Environmental Planning Commission

Agenda Number: 3
Project #: 2021-005301
Case #: SI-2021-00452
Hearing Date: July 15, 2021

Supplemental Staff Report

**RE: DUTCH BROTHERS MAJOR AMENDMENT 7 BAR- EPC
RESPONSE TO COMMENTS PR-2021-005301/SI-2021-00452
3615 HWY 528, ALBUQUERQUE NM 87114
ZONE ATLAS PAGE A-14-Z**

BUILDING ELEVATIONS
COLOR

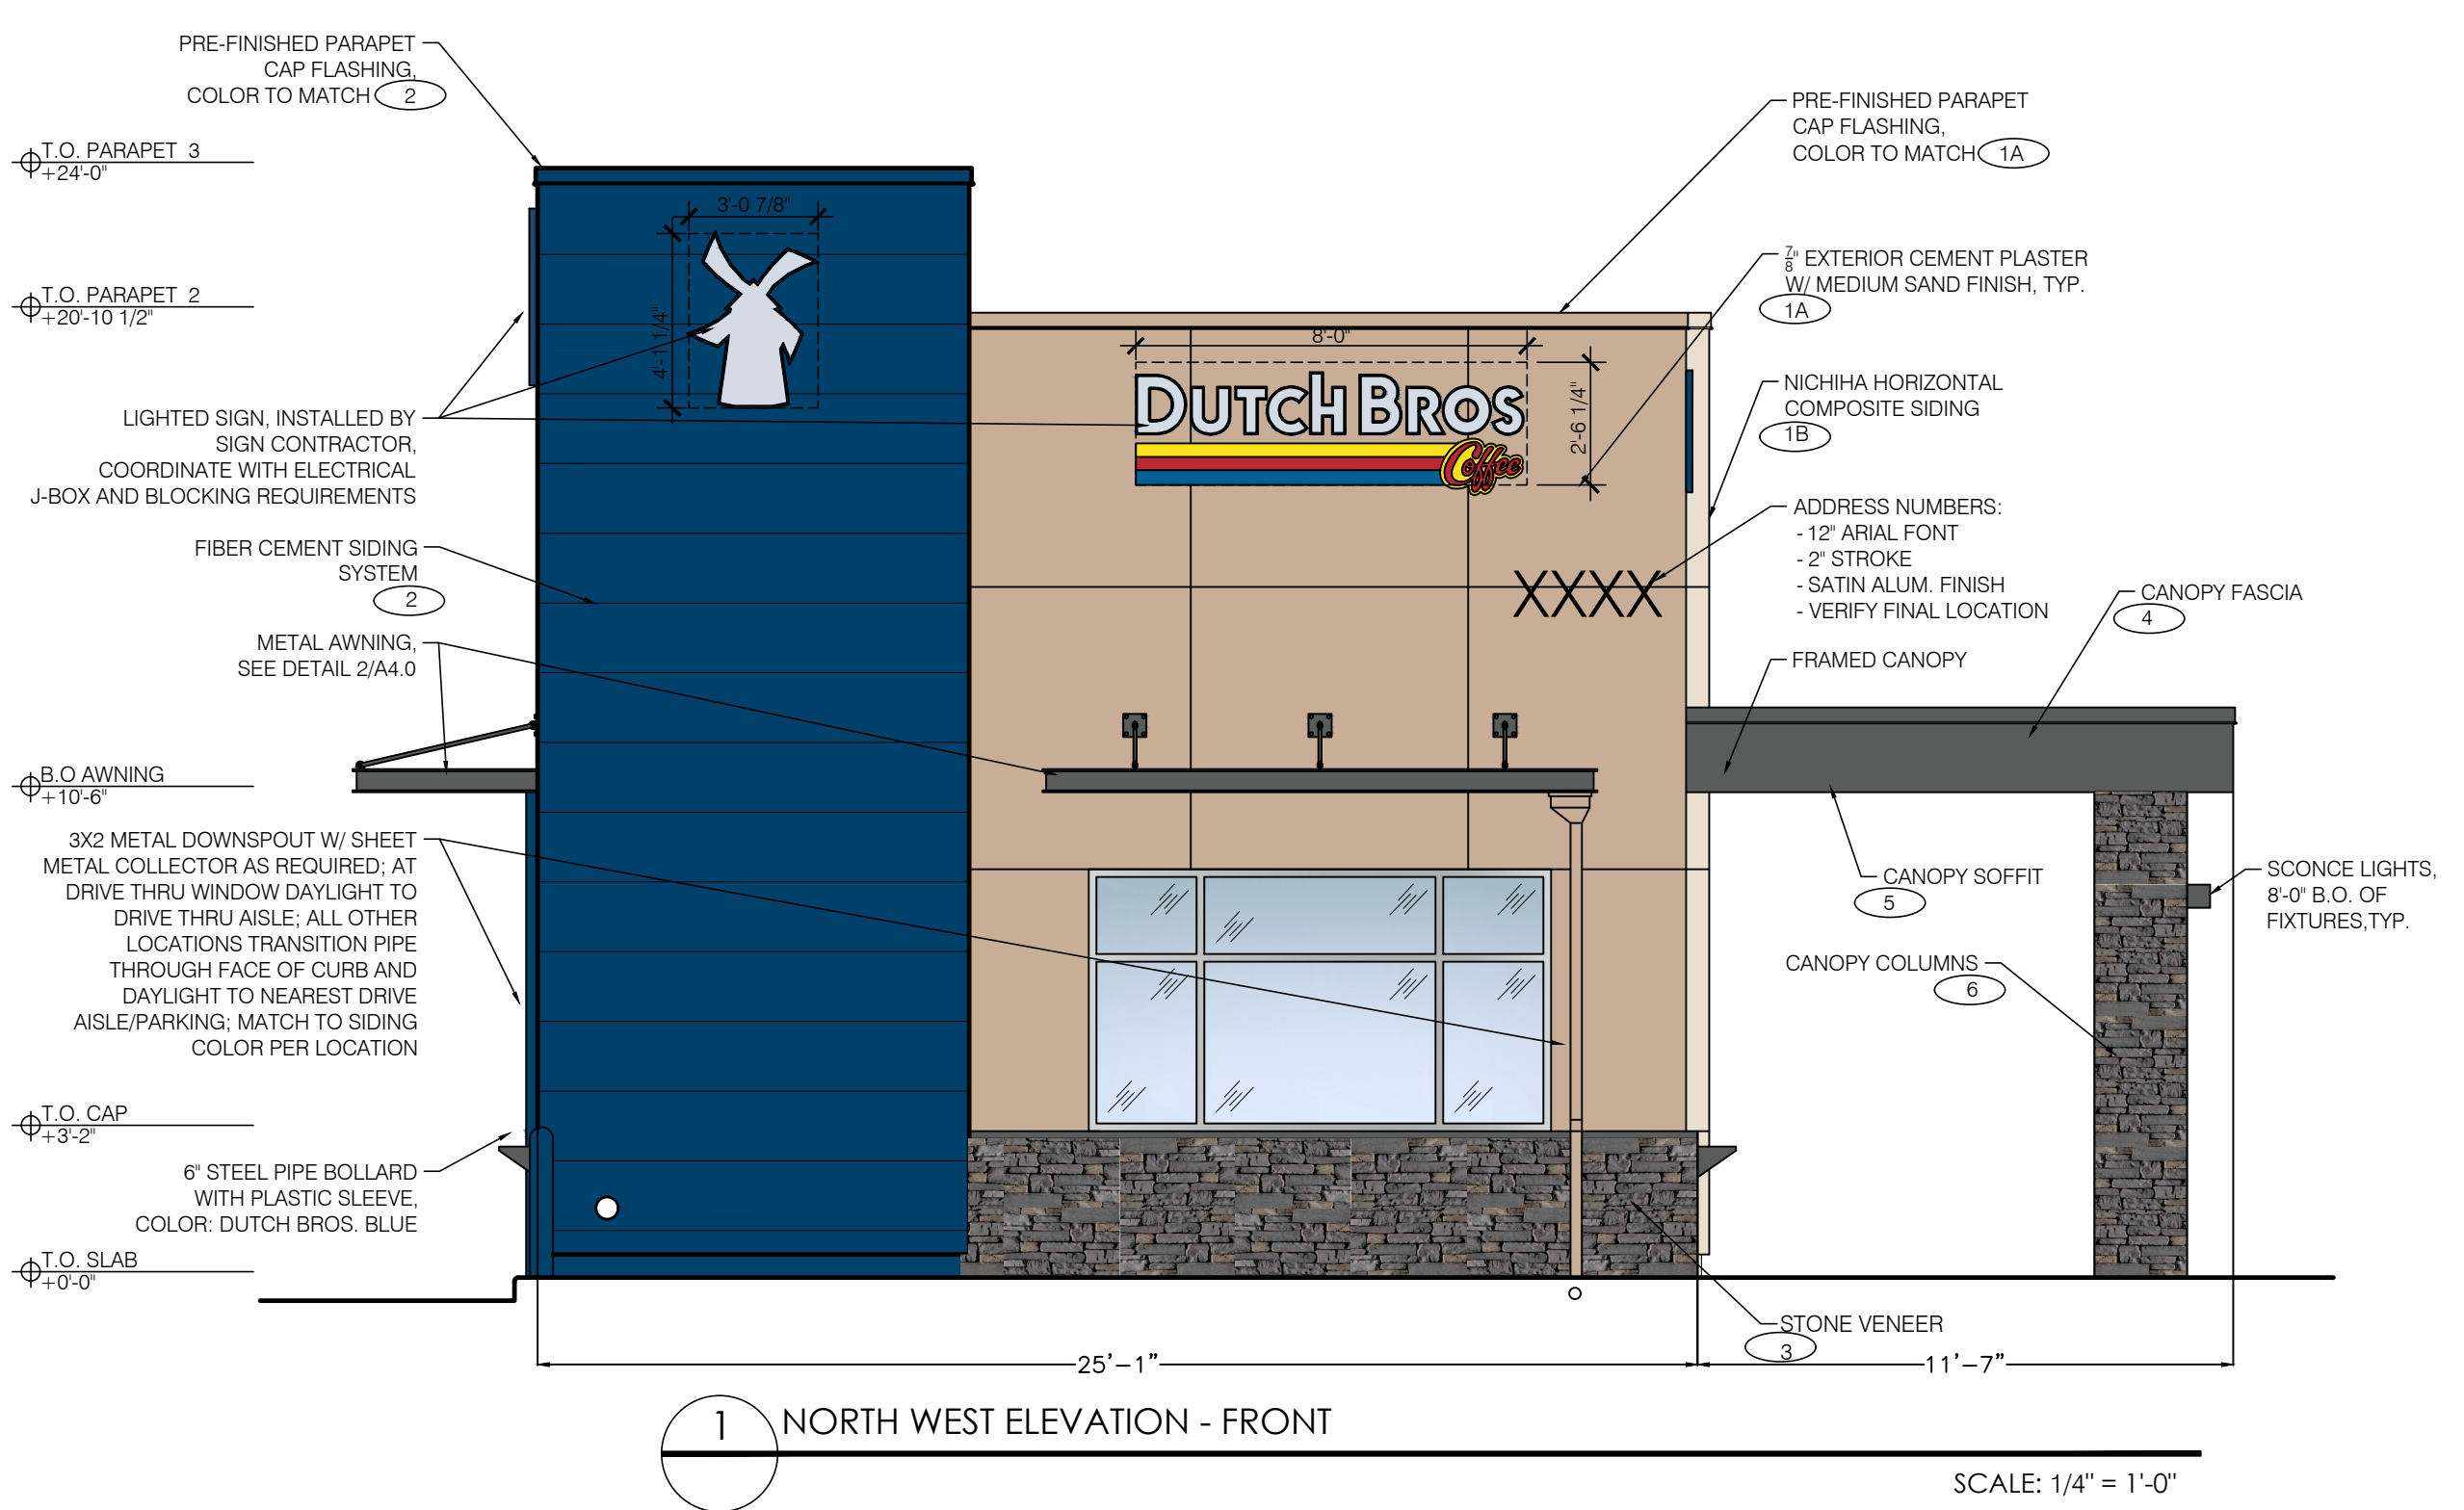
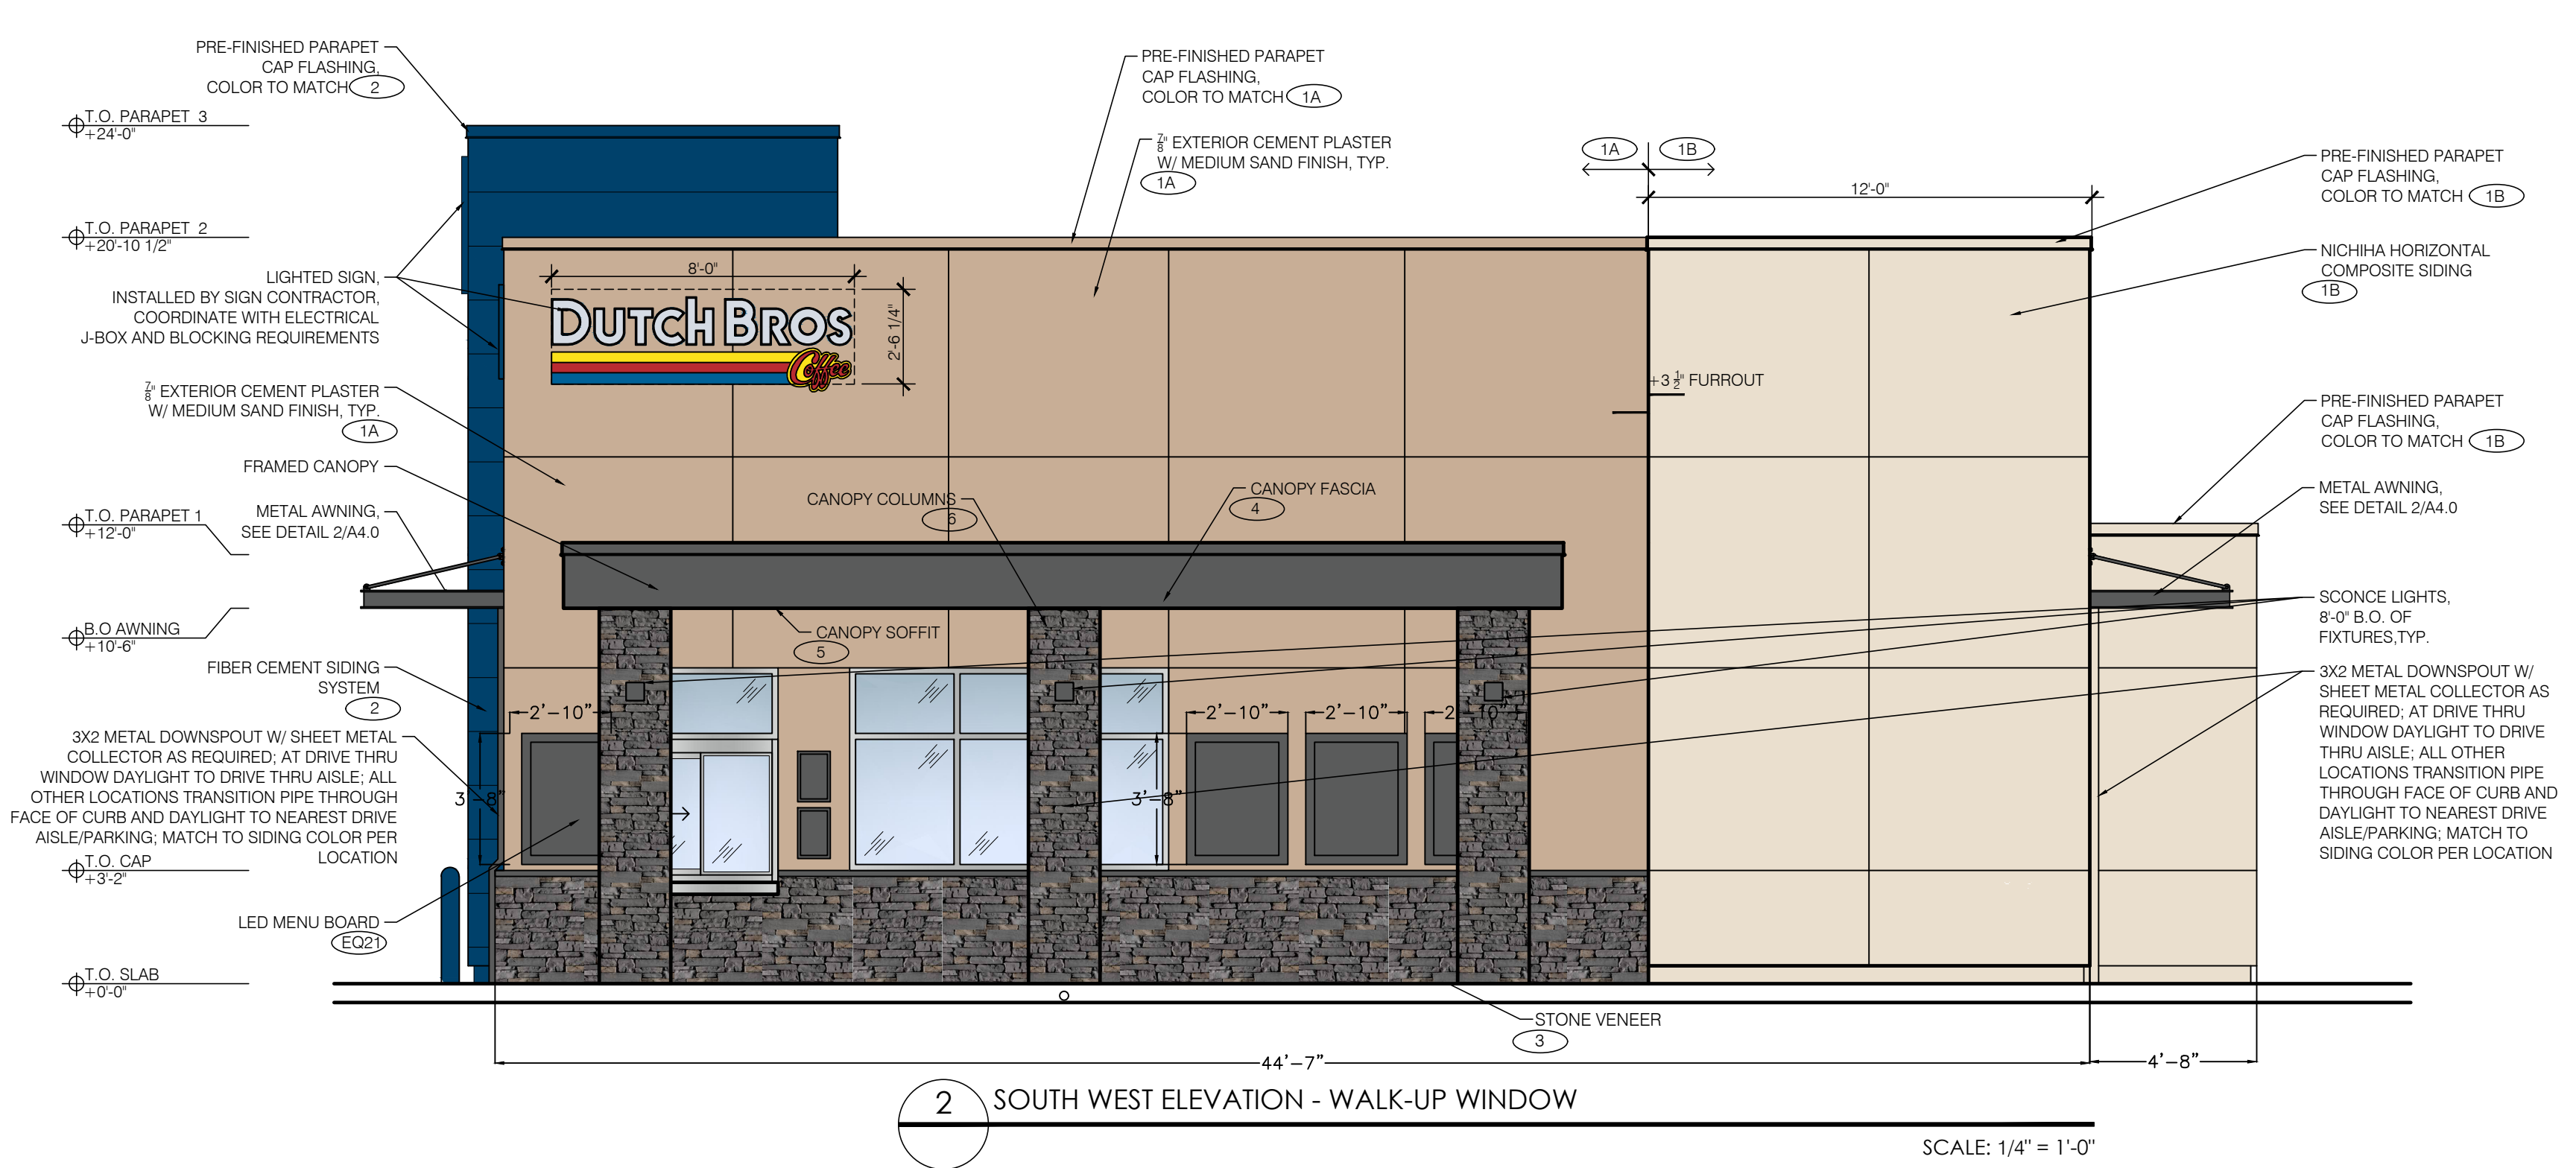
Additional building-mounted signage was added in the form of order boards: 3 new order boards on the SW elevation and 2 on the NE elevation, which faces the neighborhood. Neighbors have requested that no signage face them; a compromise is to remove the approximately 20 sf brand name sign (the square footage of which is made up for by the addition of more order boards). The logo sign on the northeast elevation should not be illuminated since it faces the neighborhood, though the logo sign facing the roadway would remain illuminated.

Response: Building mounted LED menu boards located on south west elevation faces the NM 528 ROW. Revision made to landscaping plan sheet LS-01, two pine trees were added just west of the Dutch Brothers to screen the view from NM 528. Order boards are dimensioned on the elevation plans sheet A6.1. Per the dimensions shown the gross sf of the menu boards do not exceed 50 sf with a total of 44.15 sf on either face of the building.

Response: Revisions made to elevations, sheet A6.1.
